Proposal for amendments to ECE/TRANS/WP.29/GRVA/2020/8

Note: This informal document is combining the proposed changes of ECE/TRANS/WP29/GRVA/2020/8 with the adopted changes in ECE/TRANS/WP.29/GRVA/2019/24, agreed in the September 2019 GRVA session

ACSF C – Case where the lateral movement is initiated automatically (1 Step HMI)

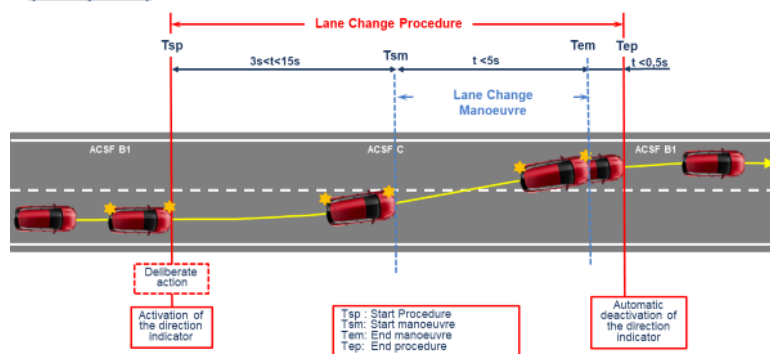
In case of an automatic initiation the lane change manoeuvre shall commence between 3.0 seconds and ~~15.0~~ 5.0 seconds after the manual activation of the procedure as described in paragraph 5.6.4.6.2. and shown in the Figure below.

If the ACSF function has not commenced the lane change manoeuvre 10.0 seconds after the deliberate action of the driver, the driver will be notified through an acoustic or visual warning when the manoeuvre is about to commence.

ACSF C – Case where the lateral movement is initiated by a second deliberate action by the driver (2 Step HMI)

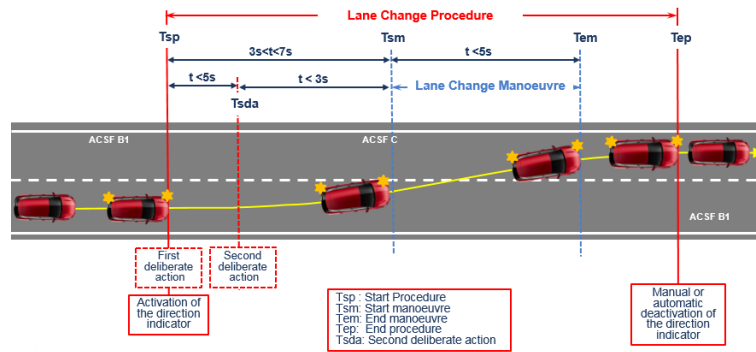
In case of an initiation by a second deliberate action the lane change manoeuvre shall commence between 3.0 and 7.0 seconds after the manual activation of the procedure as described in paragraph 5.6.4.6.2.

Additionally, the lane change manoeuvre shall commence at the latest 3.0 seconds after the second deliberate action as shown in the Figure below.

The control to operate the second deliberate action shall be located in the steering control area."
